Site Instruction

SI 24

PROJECT : Hampton Manor
PROJECT No : 1136.13
DATE : August 14, 2018

Title: Removal of Insulation behind Precast

scupper detail @ roof precast 5
SCALE - 1/4\"/>

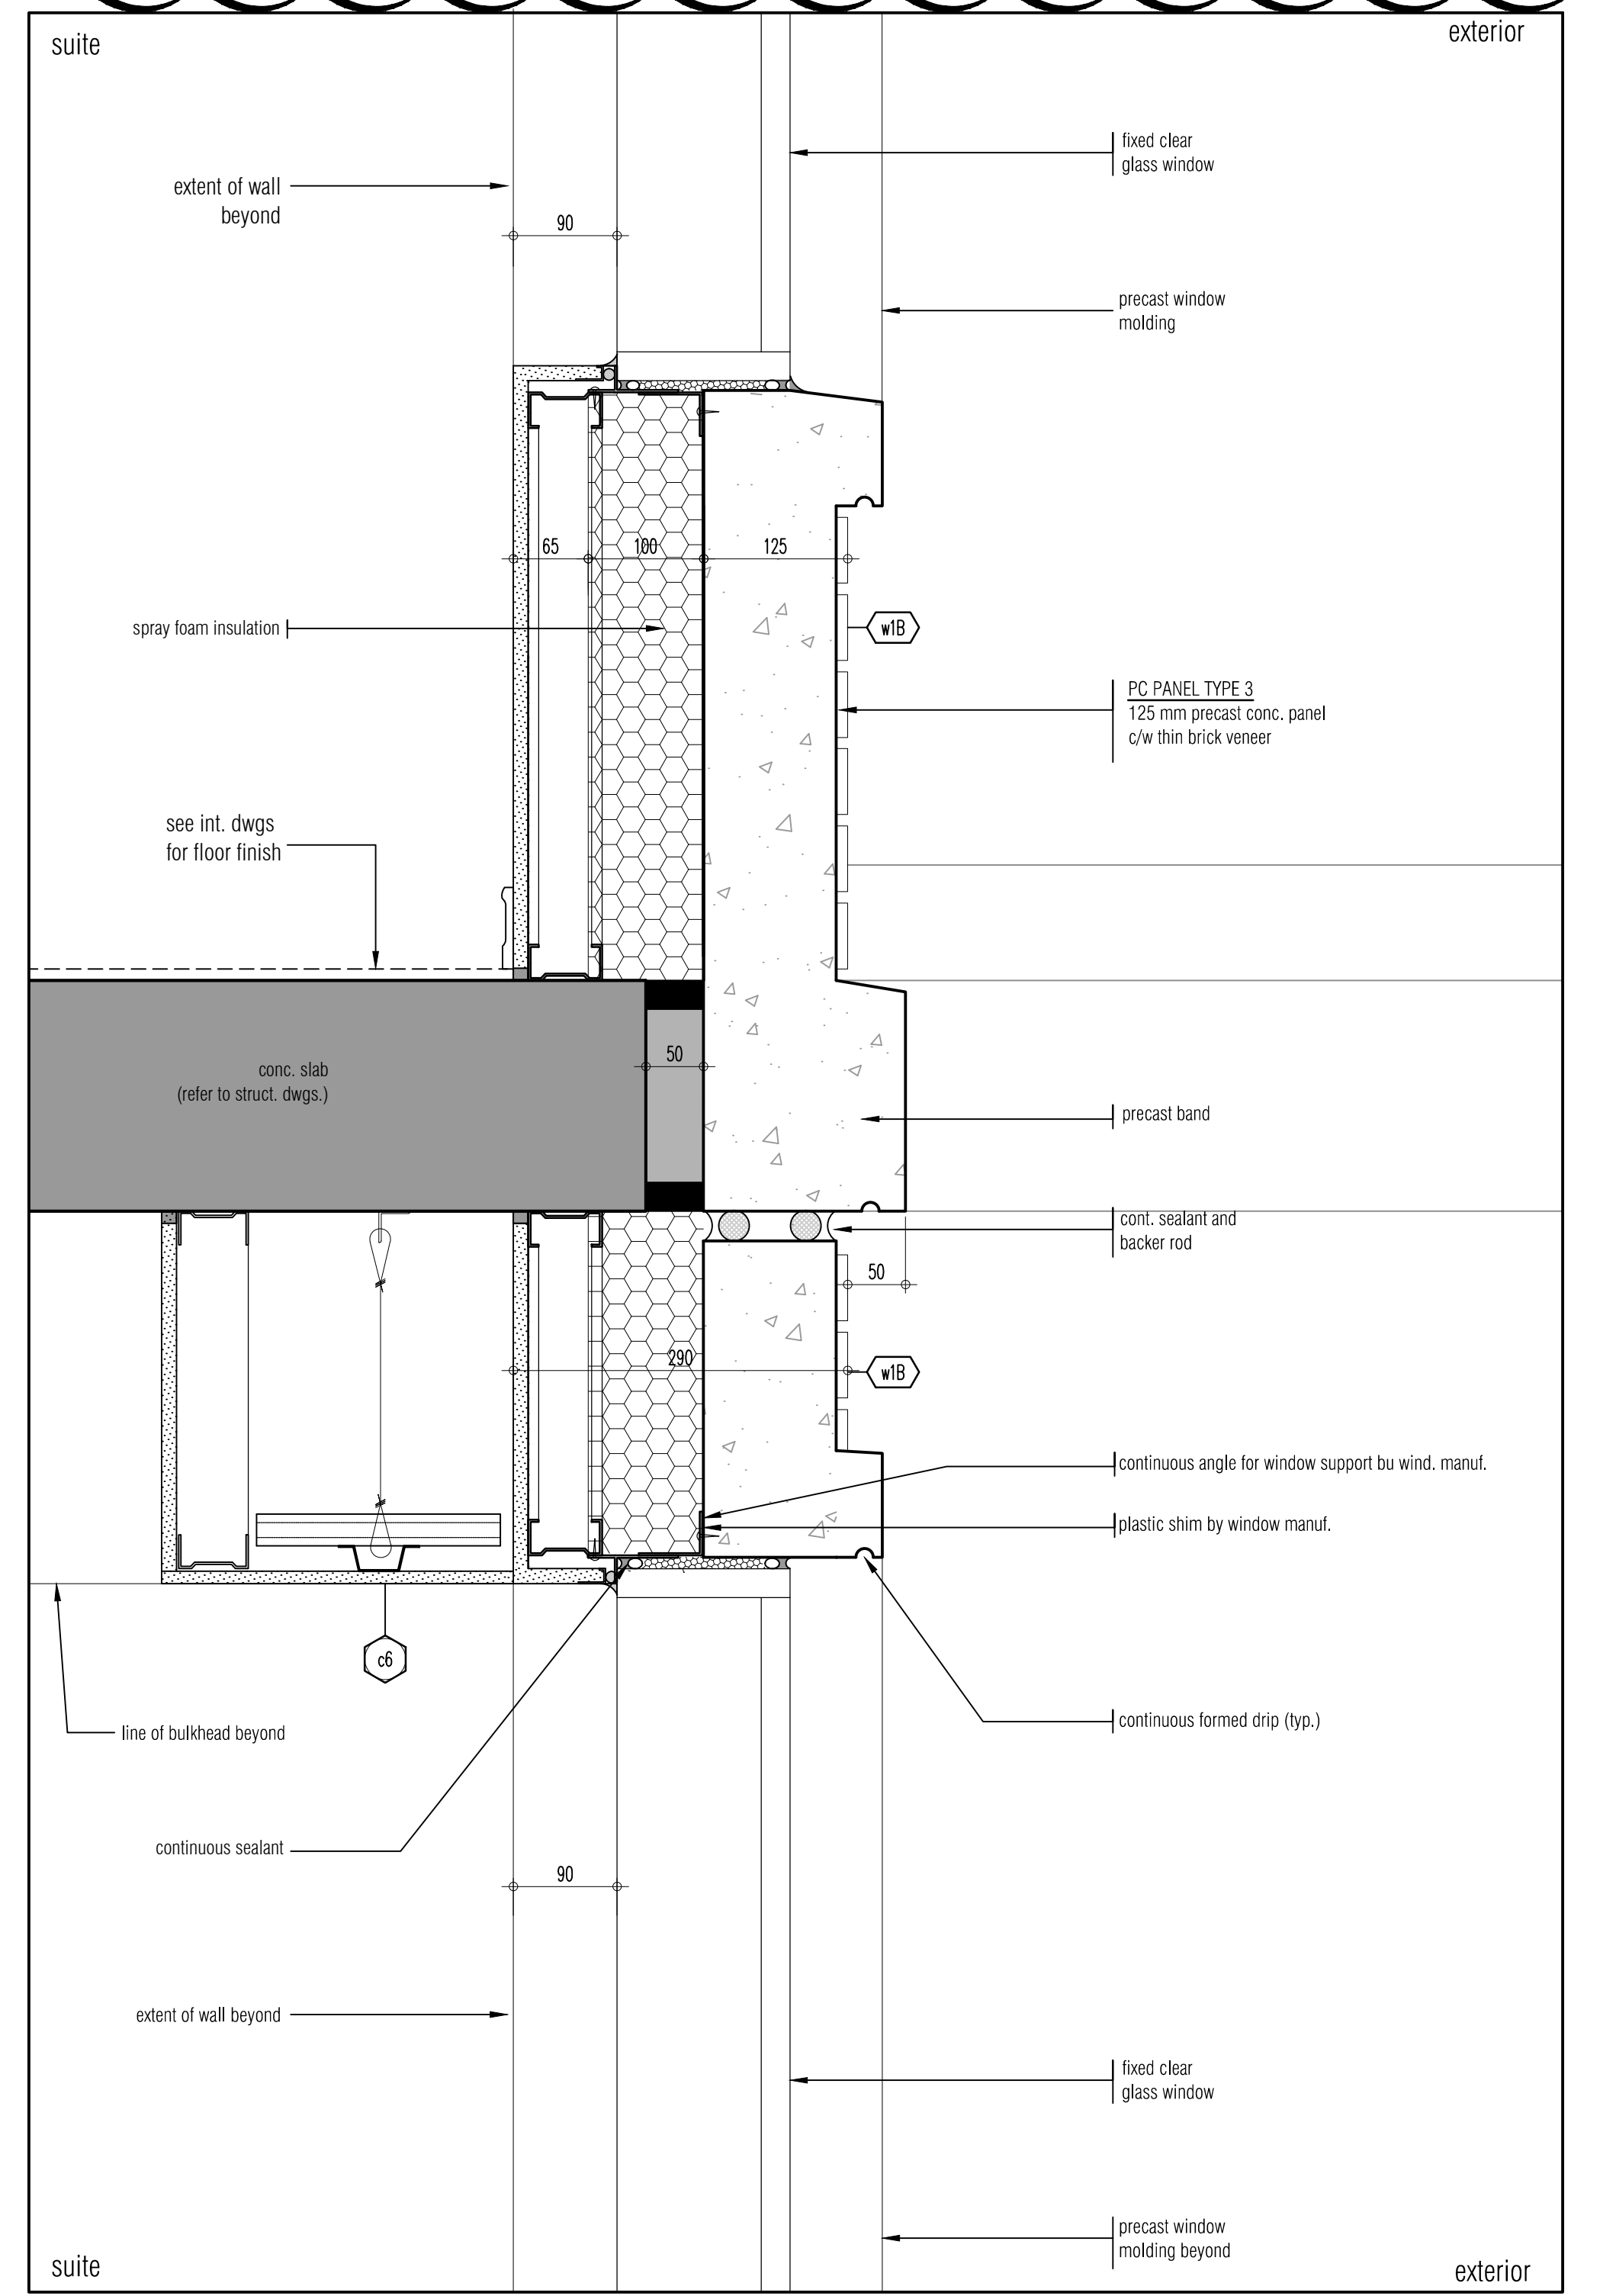
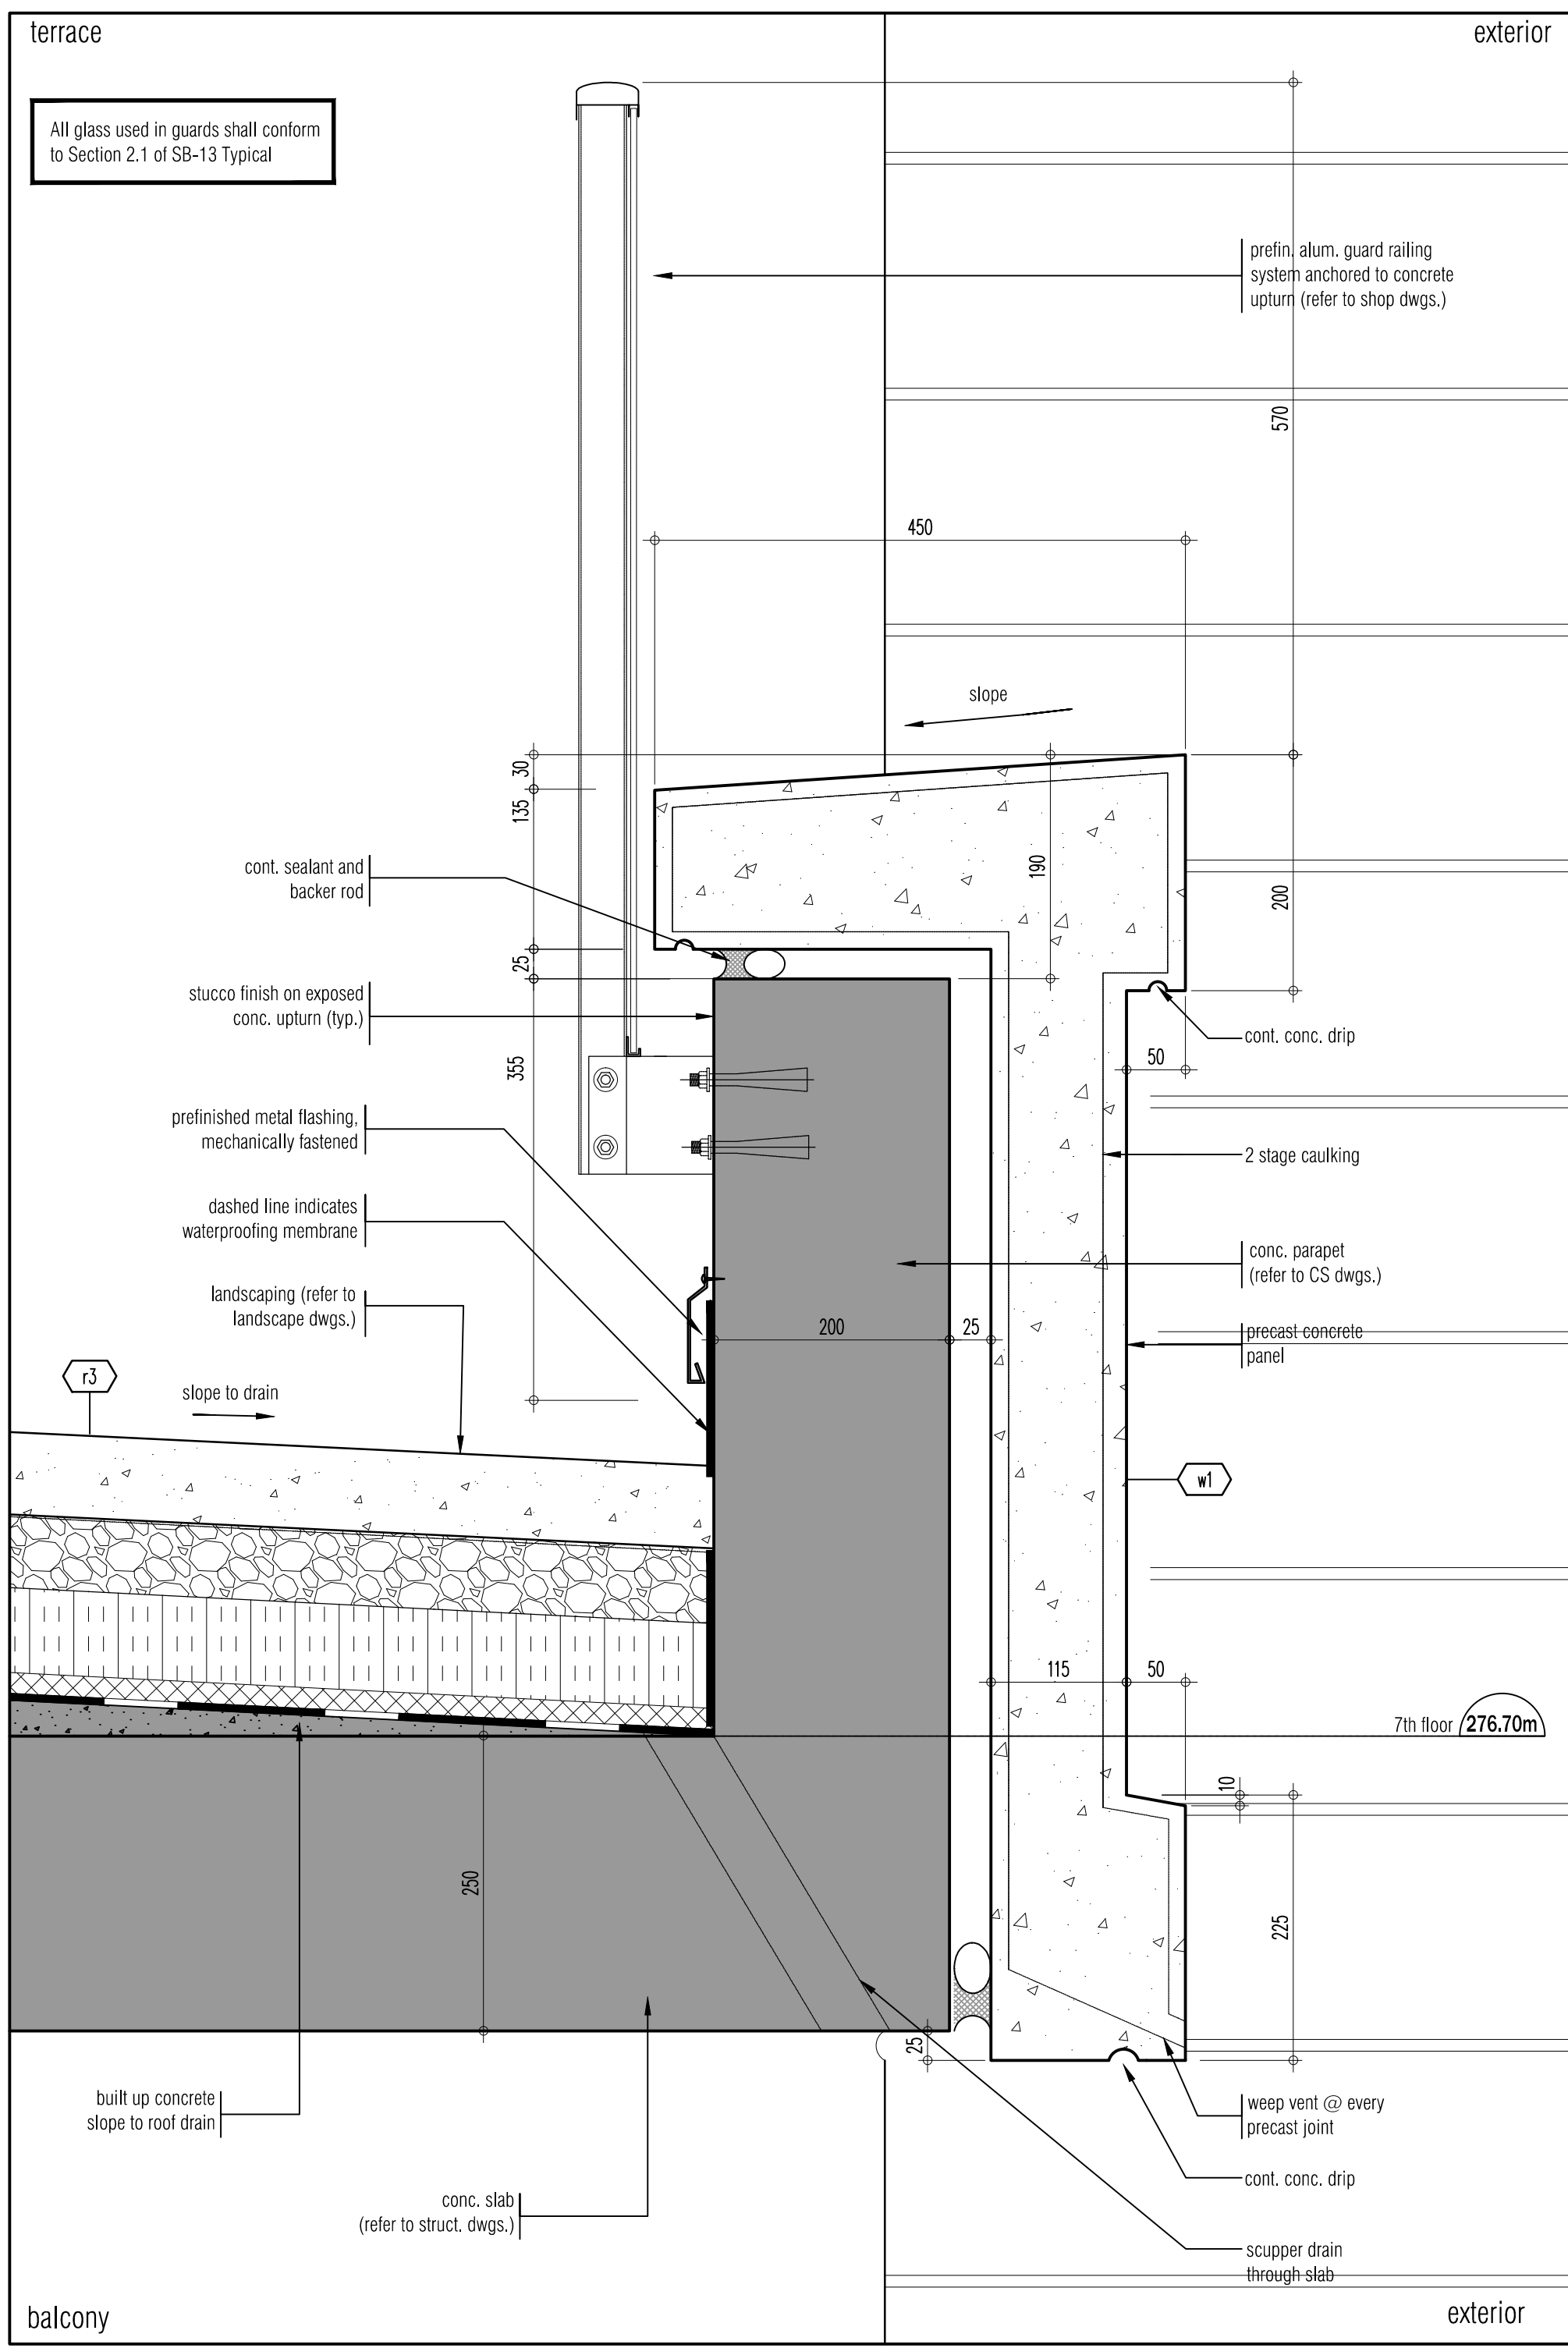
- Removal of insulation behind precast at terraces and roof.
